COTTAGE GROVE CITY COUNCIL

July 17, 2024

- H Sale of Surplus Property
Staff Recommendation: Authorize Public Works to advertise and sell surplus property on Cranky Ape.
 - I Utility & Engineering Building Change Orders
Staff Recommendation: Approve the June 2024 Change Order Requests for the Utility & Engineering Building Project.

FOOTING AND FOUNDATION PLAN - AREA A

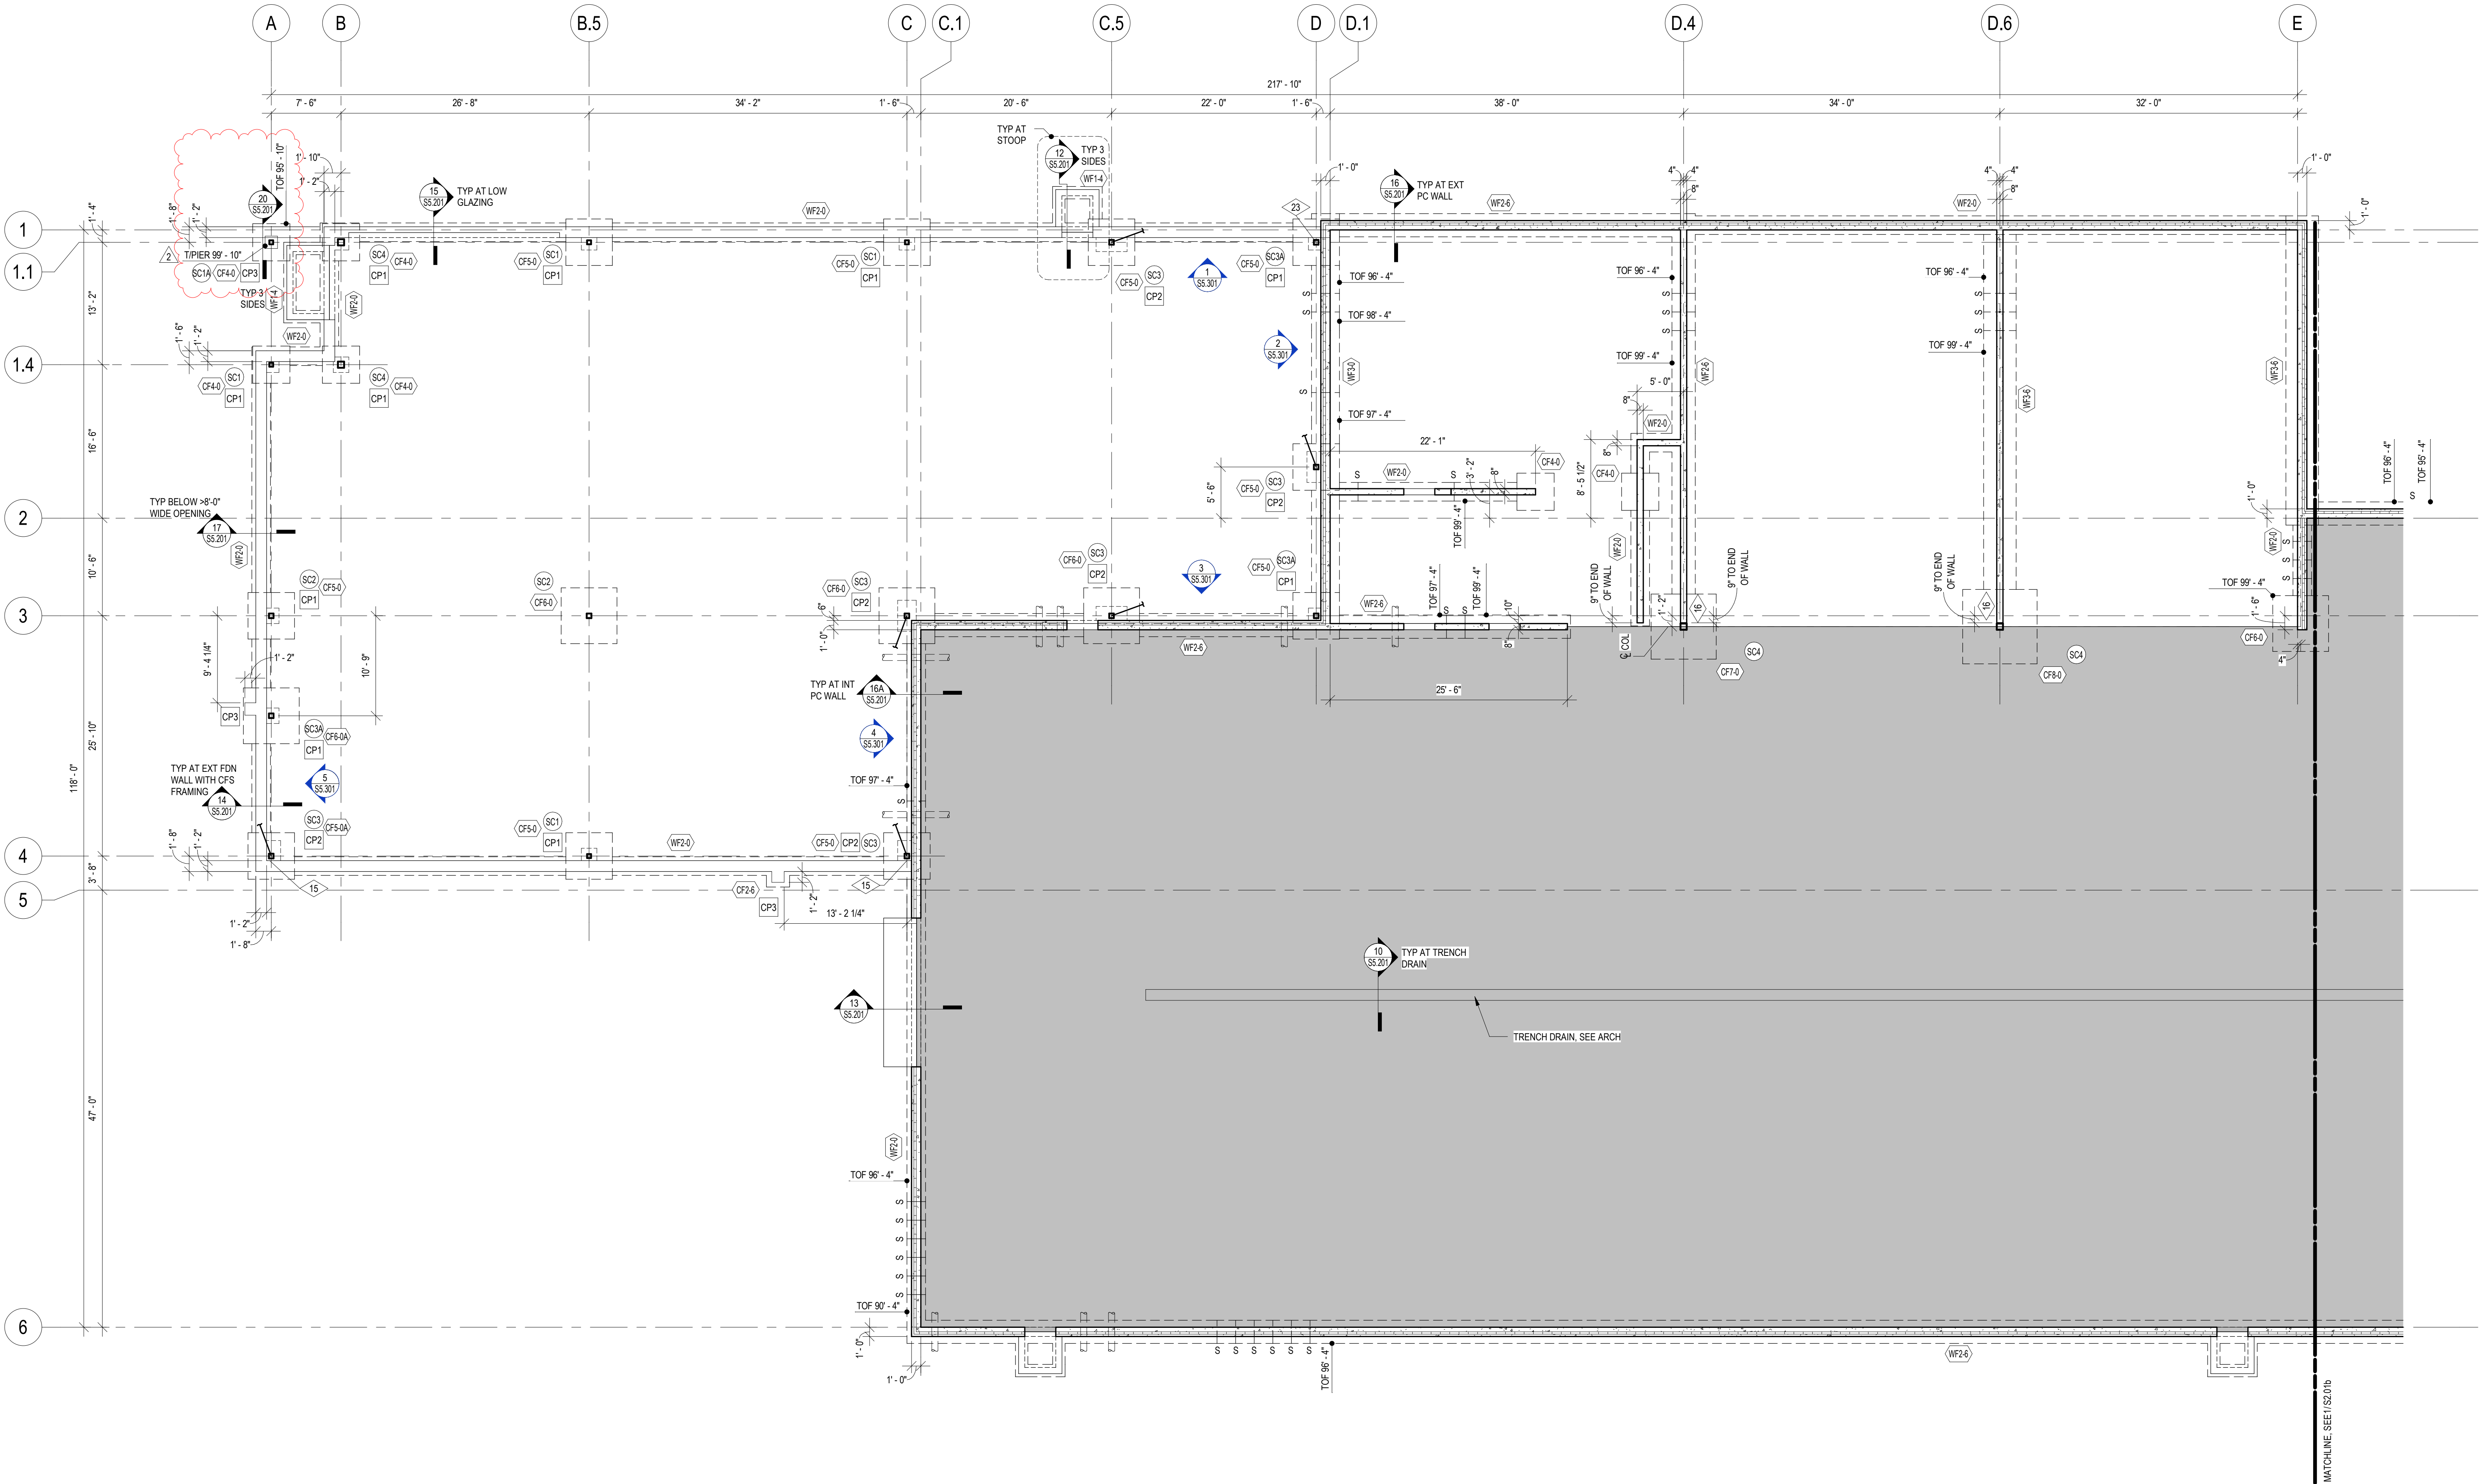
Item	Description
1	Canopy Column Pier Revision
1.1	See plan on sheet S2.01a for revised top of pier elevation.
1.2	Refer to sheet S5.201 for modified pier detail.
1.3	Refer to sheet S6.201 for modified steel column schedule.

MEZZANINE LEVEL FLOOR PLAN - AREA A

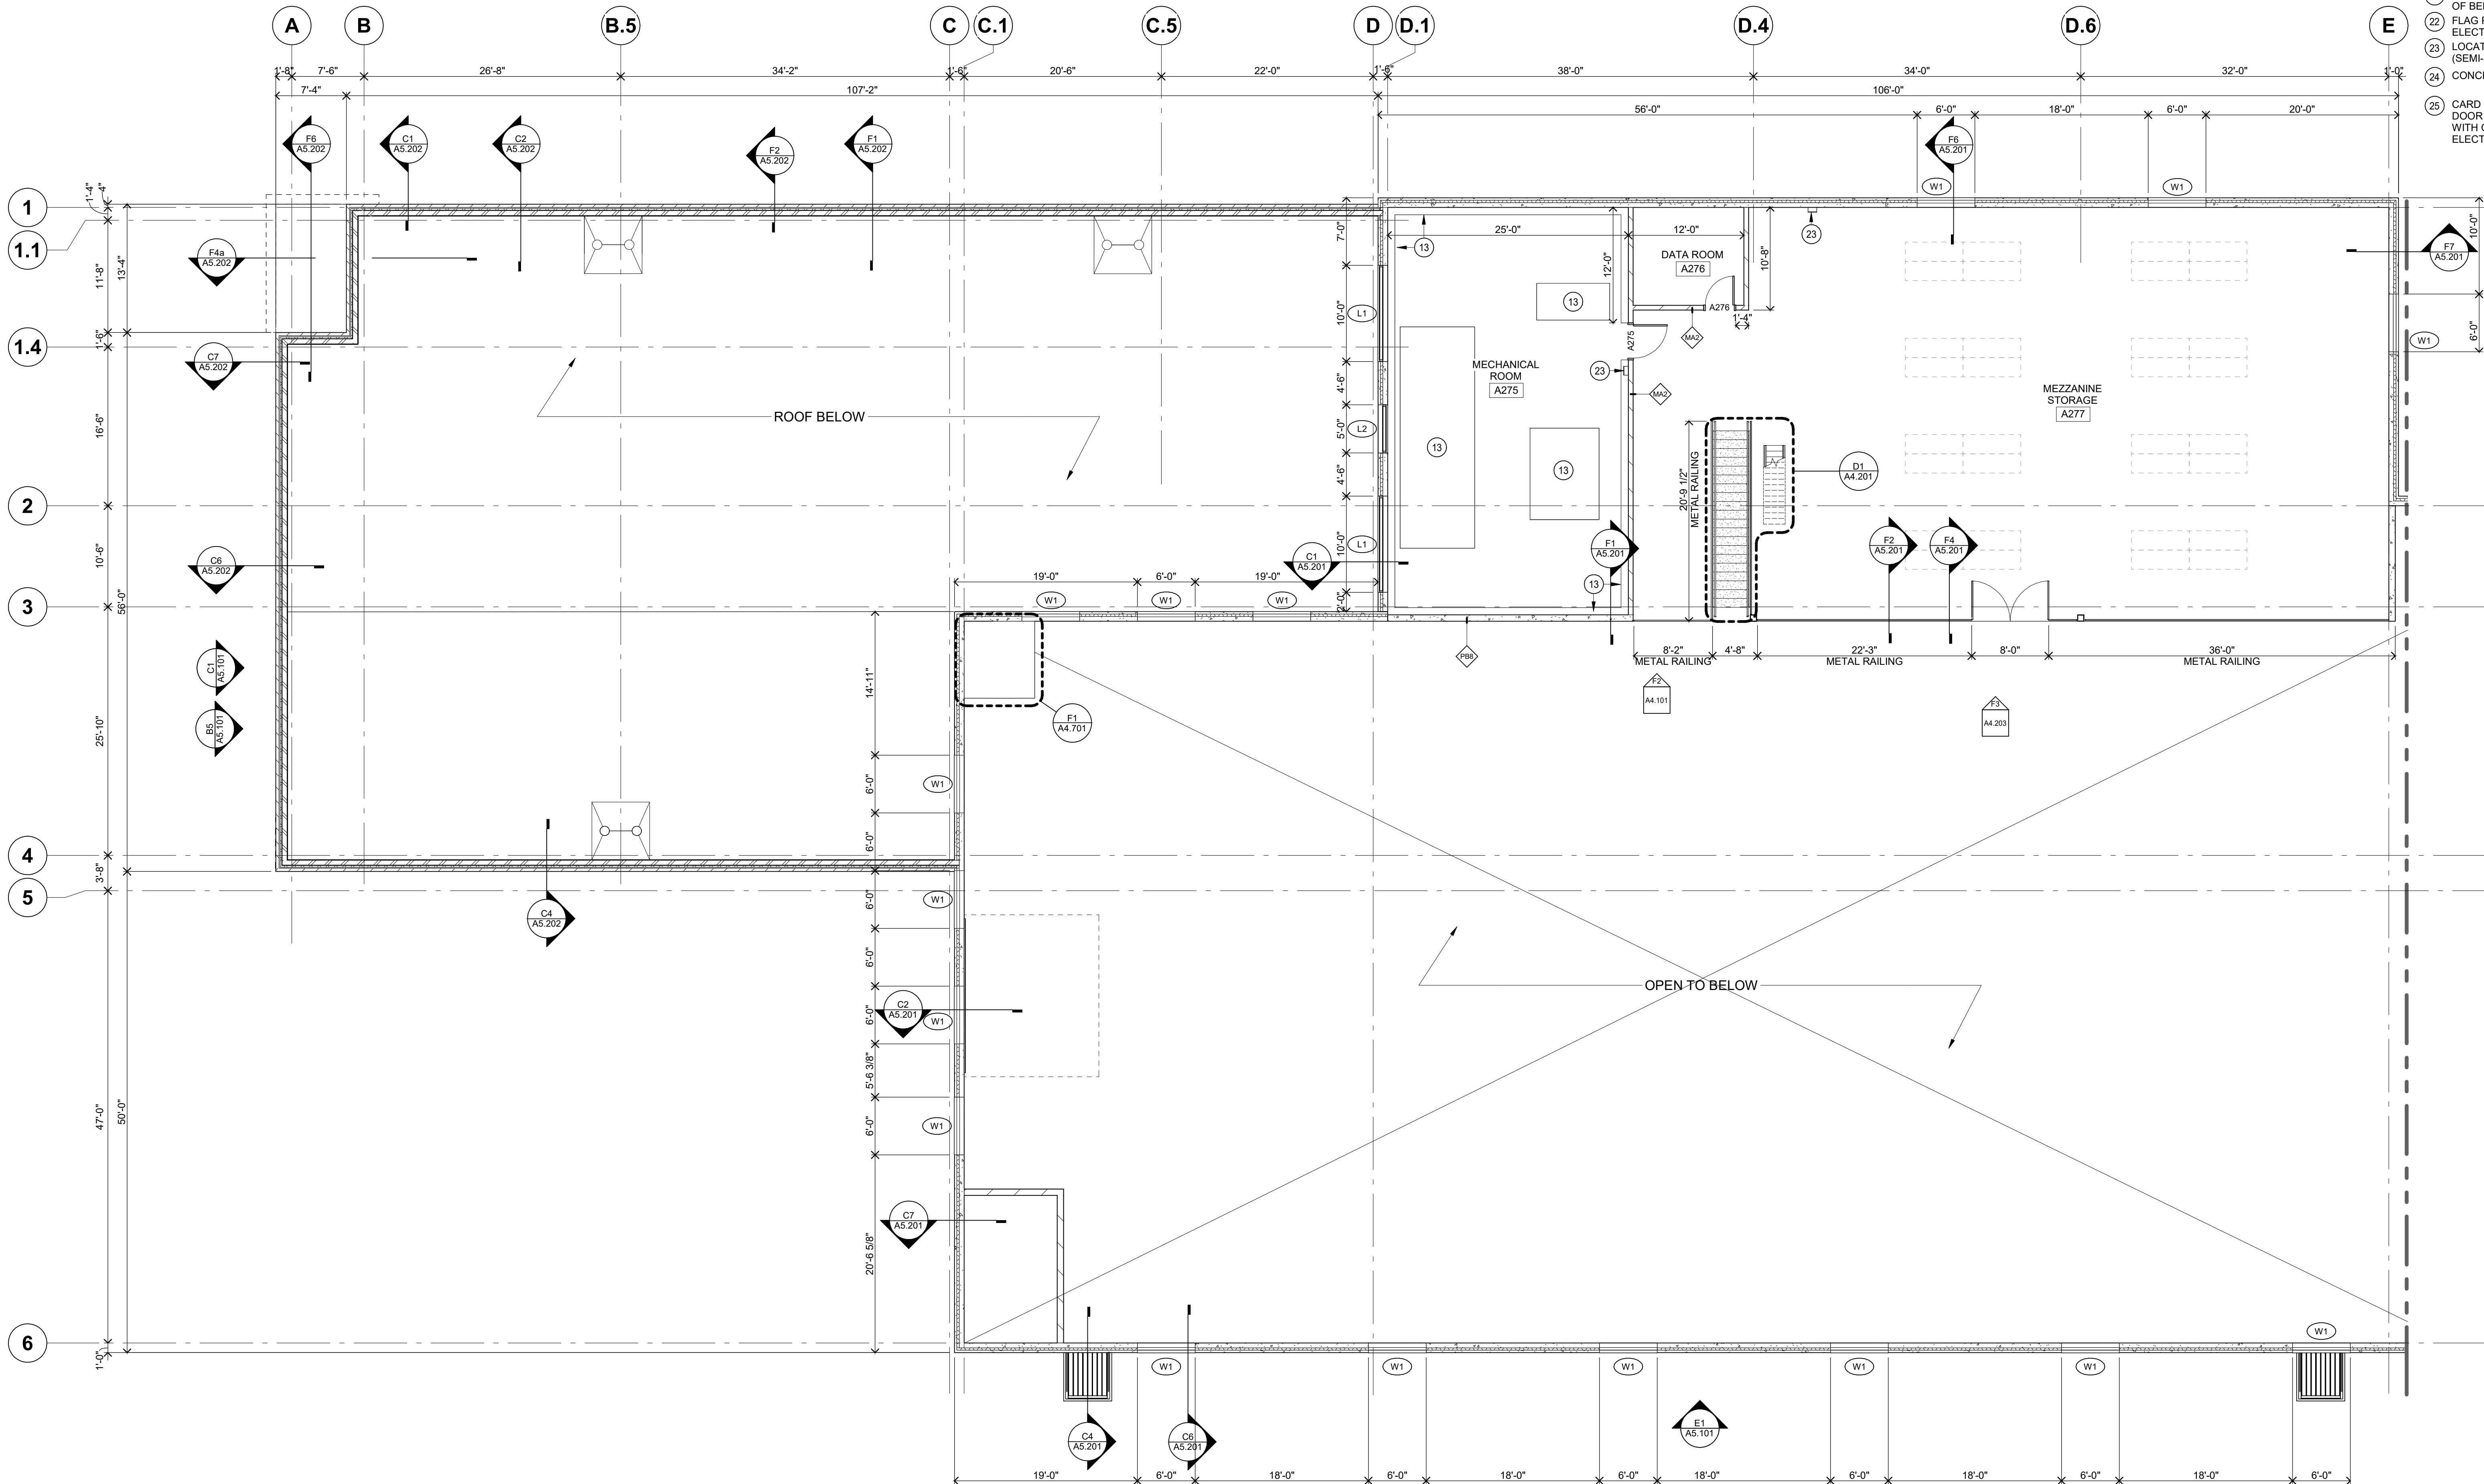
Item	Description
1	Doors & Frames Revision
1.1	See Door / Opening Schedules on sheets A2.01a and A2.02a for modified frame type, overall width, and mounting conditions.
1.2	Refer to plan on sheet A2.01a for modified interior wall type in room A126 and overall width of doors A104, A105, A106, A107, and A108.
1.3	Refer to sheets A2.901 for modified door types, frame types, and louver types.
1.4	Refer to interior elevation on sheet A4.101 for revised frame type on doors A126B, A130A, A131A, A275, A276.
1.5	Refer to north elevation on sheet A5.101 for revised overall height of door A115A.

10. MAIN LEVEL - CODE PLAN

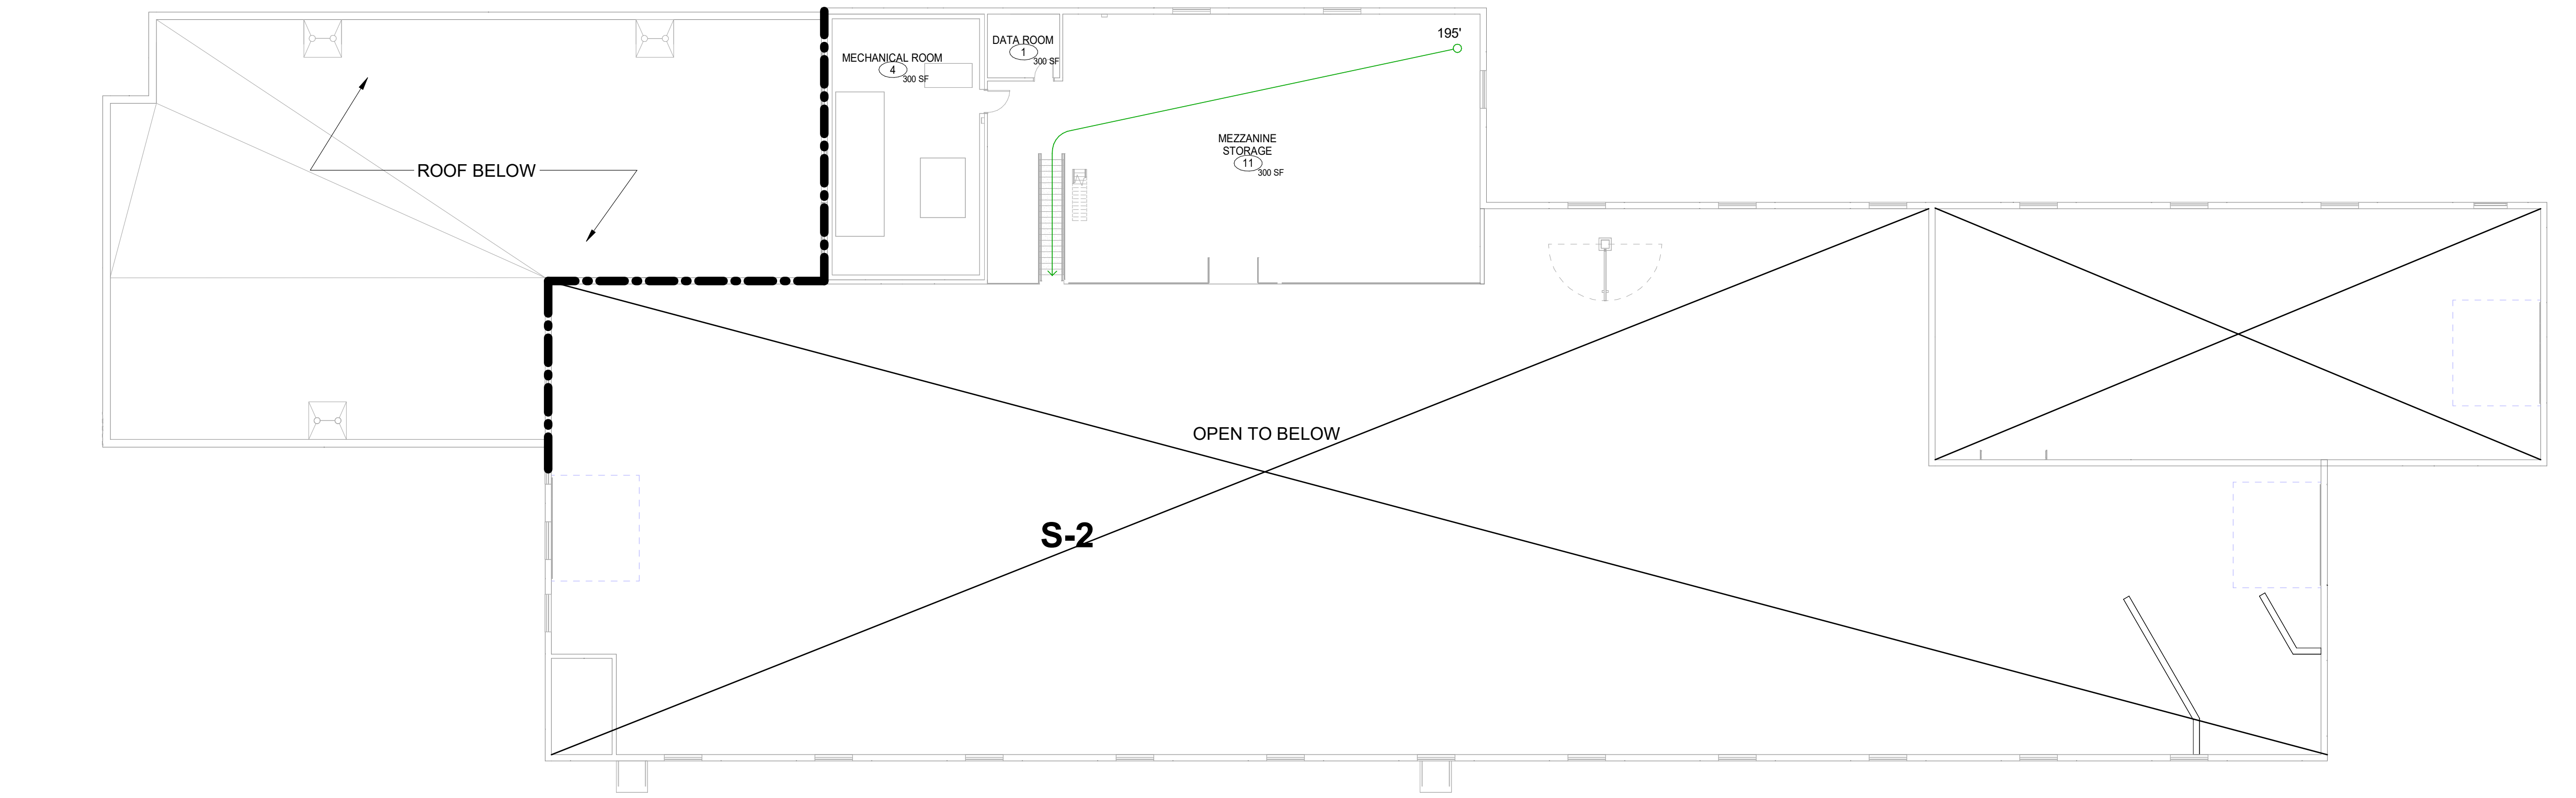
Item	Description
5	Plan Review Comments
5.1	See revised sheet A0.001 – CODE PLAN for no cost clarifications in response to the plan reviewers comments.
5.2	See revised sheet A2.01a – MAIN LEVEL FLOOR PLAN AREA ‘A’ for added 45 minute fire resistive label at doors A115B, A125, and A126A. Provide cost for added label to doors/frames.
5.3	See revised sheet A2.02a MEZZANINE LEVEL FLOOR PLAN AREA ‘A’ and A5.101 EXTERIOR ELEVATIONS for removed windows. Provide credit for the (3) removed windows.
